SUBJECT: Michigan Department of Environmental Quality Comments for Draft Area 2 Supplemental Remedial Investigation Report, Allied Paper, Inc./Portage Creek/Kalamazoo River Superfund Site

Area 2 SRI

MDEQ Comments

Figure
1

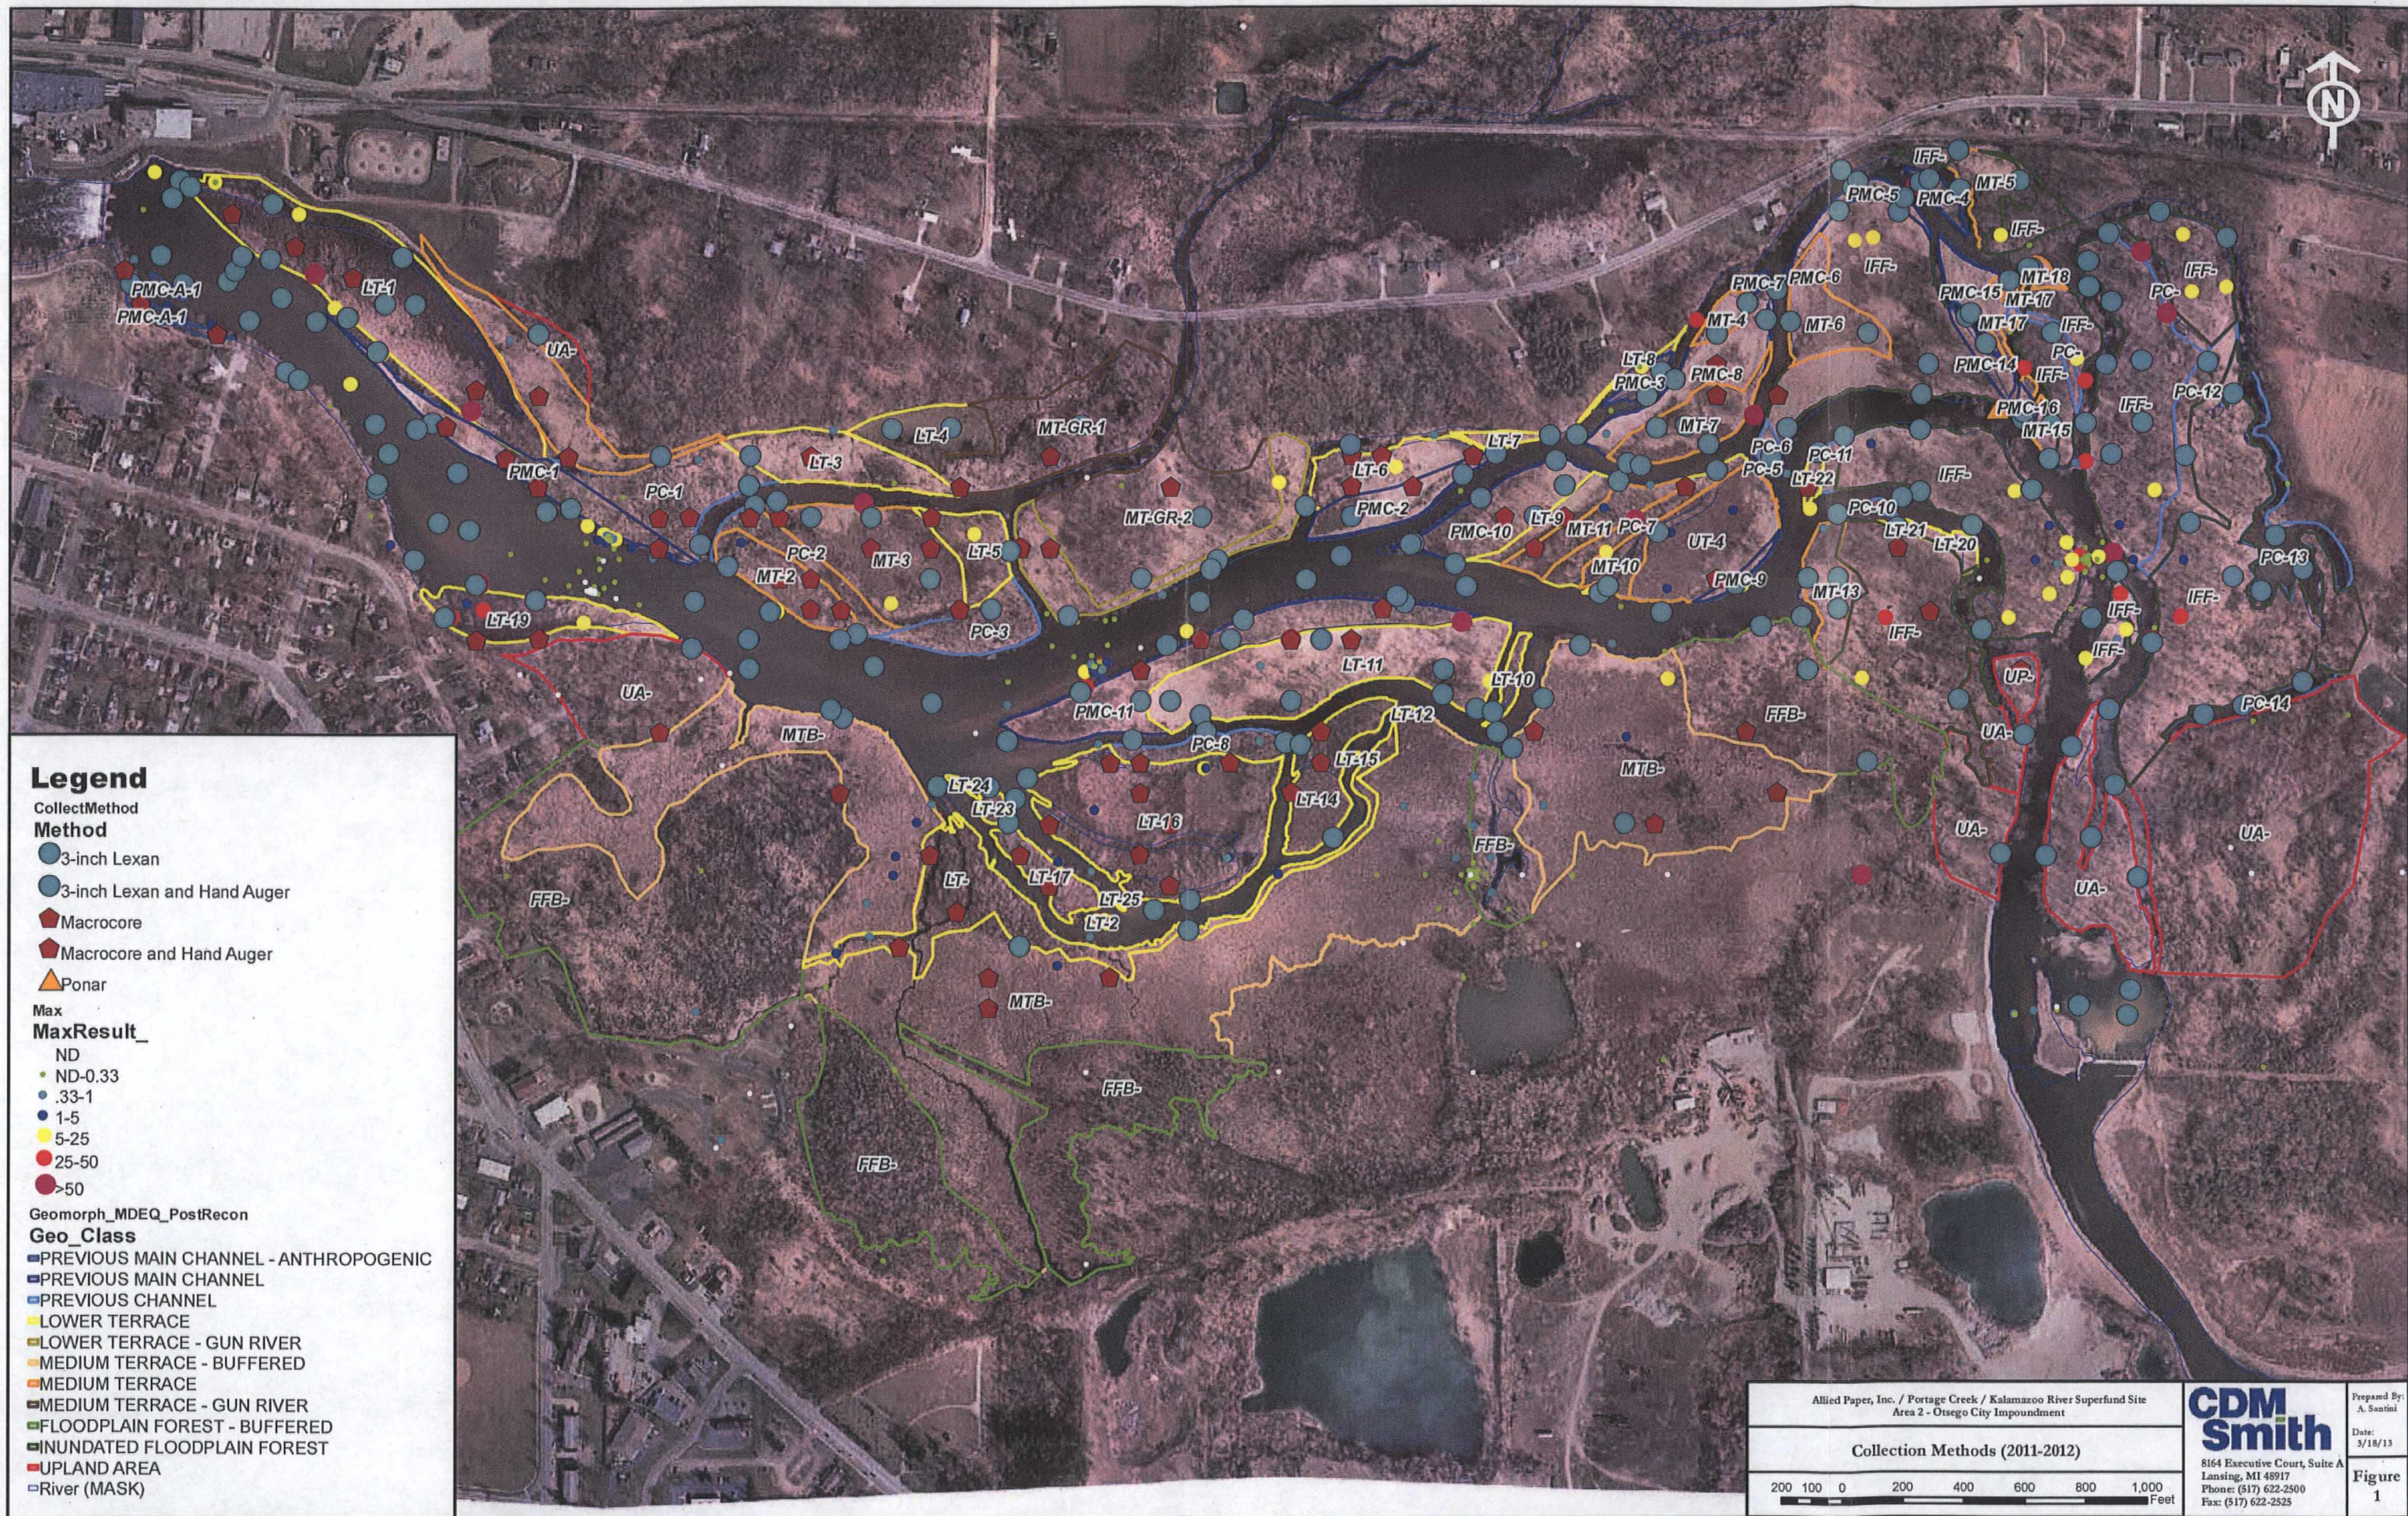
- a) Presented in Attachment A Table is a summary of the floodplain cores collected within Area 2 in 2011 and 2012 (no previous RI or EPA cores). PCB data are grouped by MDEQ's geomorph ID and collection method. Sample count, core penetration, and core recoveries are also presented. For those locations collected using a hand auger, in conjunction with a Macro-Core, it may appear that penetration and recovery depths are deeper and/or similar to Lexan, however, the Macro-Core compressed and/or pushed material away so the data are not as useful. One example where Macro-Core and Lexan data interpretations are different is at LT-6 and PMC-2 (island east of Gun River and north of 'knife blade'). are yellow and relate to clay island). The table shows how the Macro-Core locations on this island significantly underestimate PCB mass and volume.
